ADDENDUM 001

St. Louis Economic Development Partnership for Constructing or Improving Olive / Lindbergh Interchange STP-4922(604)

- 1) Itemized Bid Form Page 2 of 8 will replace optional pavement for mainline and ramp options.
- 2) JSP Provisions Table of Contents, Page 1, JSP N, pavement construction will be removed.
- 3) JSP Provisions Table of Contents, Page 2, JSP GGG, optional pavement will be added.
- 4) Typical Section Sheet 1 of 3, will revise pavement design table.
- 5) Summary of Quantities Sheet 1 of 4, will add note on earthwork schedule.
- 6) Summary of Quantities Sheet 2 of 4, will revise optional pavement on pavement schedule.

GGG. Optional Pavements

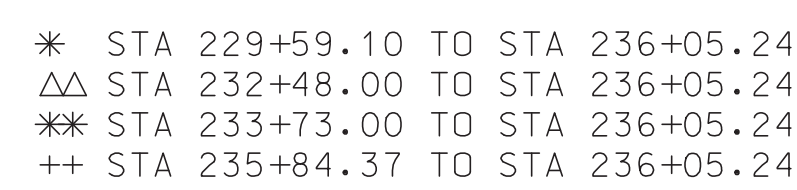
3.0 Method of Measurement. The quantities of concrete pavement will be measured in accordance with Section 502.14. The quantities of asphaltic concrete pavement will be measured in accordance with Section 403.22.

4.0 Basis of Payment. The accepted quantity of the chosen option will be paid for by the contract unit bid price for Items:

Item No.	Unit	Description
403-99.05	Square Yard	Misc. Optional Pavement (Mainline Pavement)
403-99.05 {1}	Square Yard	Misc. Optional Pavement (Ramp Pavement)
